**AGENDA  
CITY OF CEDAR FALLS, IOWA  
PLANNING AND ZONING COMMISSION MEETING  
WEDNESDAY, JUNE 28, 2023  
5:30 PM AT CITY HALL, 220 CLAY STREET**

**TO:** Planning & Zoning Commission  
**FROM:** Jaydevsinh Atodaria (JD), City Planner I  
Matthew Tolan, Civil Engineer II  
**DATE:** June 28, 2023  
**SUBJECT:** The Autumn Ridge Master Plan Amendment (MP23-002)

**REQUEST:** Request to approve revised Autumn Ridge Master Plan

# MASTER PLAN - AUTUMN RIDGE NINTH AND ELEVENTH ADDITIONS CEDAR FALLS, IOWA

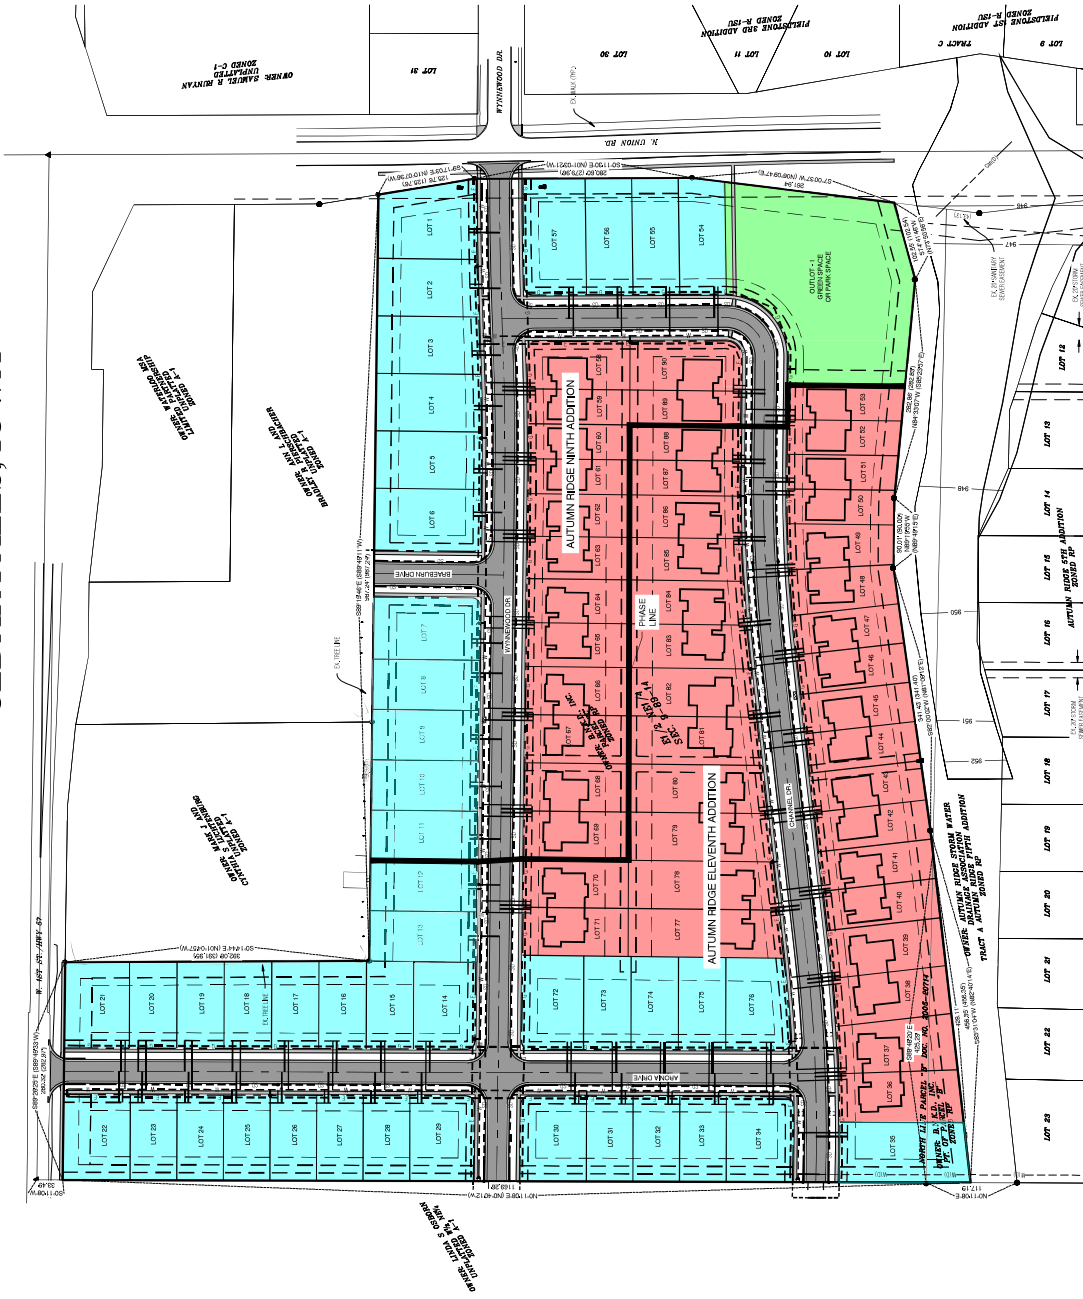
The Master Plan exhibit submitted with the current revised application highlights the two remaining phases (9<sup>th</sup> and 11<sup>th</sup>) in the subdivision in context with the rest of the development in Autumn Ridge. The updated RP master plan proposed by the developer is described below, with areas of change from the original plan highlighted and staff recommendations noted.

The last remaining area of development for Autumn Ridge is located just south of W. 1<sup>st</sup> Street and north of the east-west drainage way that separates the subject area from the developed portion of Autumn Ridge. This area will be accessed from both W. 1<sup>st</sup> Street and Union Road. Wynnewood Drive would be extended westward from Union Road and streets would be stubbed to the western boundary of the development to provide for future development to the west. The 9<sup>th</sup> and 11<sup>th</sup> Additions are planned to include 46 lots for single-unit bi-attached dwellings, 44 single-family lots and public park space. The area will be developed in two phases: Phase 1 will be Autumn Ridge 9<sup>th</sup> Addition, which will include 29 lots (15 single family dwellings, 14 single-family bi-attached dwellings and a little over one acre of public park space); and Phase 2 will be Autumn Ridge 11<sup>th</sup> Addition, which will include 61 lots (29 single family dwellings, and 32 single-family bi-attached dwellings).

While staff is not opposed to the elimination of the wet-bottomed retention stormwater basin (lake), elimination of the shared open space and amenities entirely is not recommended. In response, developer has included Outlot 1 in the proposed master plan, which is labeled as "Green Space or Park Space." The green space is proposed to be included in the first phase of development. This green space will need to be carefully graded and seeded to provide usable park space (more details about the proposed park space are included in the preliminary plat

staff report). Staff also notes that the developer proposes a sidewalk connection to access the park space from the Union Road sidewalk, to provide easy accessibility to park space for all residents of Autumn Ridge, both north and south of the drainage way, which will need to be added in Phase 1 of the project. This sidewalk connection will require the developer to regrade the previously established Union Road drainage ditch in Right of Way. Additional grading will be done to tie the southerly limit of the park space into the existing stormwater detention facility.

After the meeting, hearing similar concerns for this proposal as for the proposal that was presented in March 2022 Planning and Zoning Meeting, staff has several recommendations that may help alleviate some of the concerns. Staff recommends that the developer or their engineer provide the following information and consider changes to the Master Plan as follows:

1. Existing Stormwater Basin (South of proposed subdivision):
  - Developer to provide a clear picture of how the existing drainageway is currently functioning and how it is going to be maintained over time. For example, how it will be accessed and what is the anticipated maintenance schedule.

- Developer's engineer to provide an analysis based on the current topography to determine if the existing drainageway/stormwater basin is staying within the designated Outlot at full capacity or whether it is encroaching into the rear yards of the lots along the northside of Berry Hill Road. Given that these lots were established with very shallow or non-existent rear yards, staff recommends that the developer consider increasing the capacity of the basin to ensure that the risk of encroachment will be reduced.

2. Park space:
  - The original Master Plan (2001) and development agreement for the Autumn Ridge Development had an area designated as "3-5 acre" park space and stormwater detention area. The existing drainageway is around 3 acres in size, so staff recommends increasing the park space to approximately 2 acres, which would align with original proposal.

- Based on the sloping nature of the designated park space in the current plan and its location next to an arterial street with a 45 mph speed limit, staff recommends that the park location be moved to a centralized location, for better safety, accessibility, and usability of park space.

- As noted in the staff report, the single-family lots along Aronia Drive have shallower depths (approximately 110 feet) and a 20-foot drainage/utility easement at the rear of the lots. Since fences are not allowed within drainage easements, there will be only small area that can be fenced to provide privacy or safety for children and pets. Staff recommends reducing the number of single-family lots along Aronia Drive, so that they can be widened to provide more area for yard space or to accommodate a shallower depth house to ensure usable yard space. Staff recommends eliminating 4-6 lots to achieve this goal.
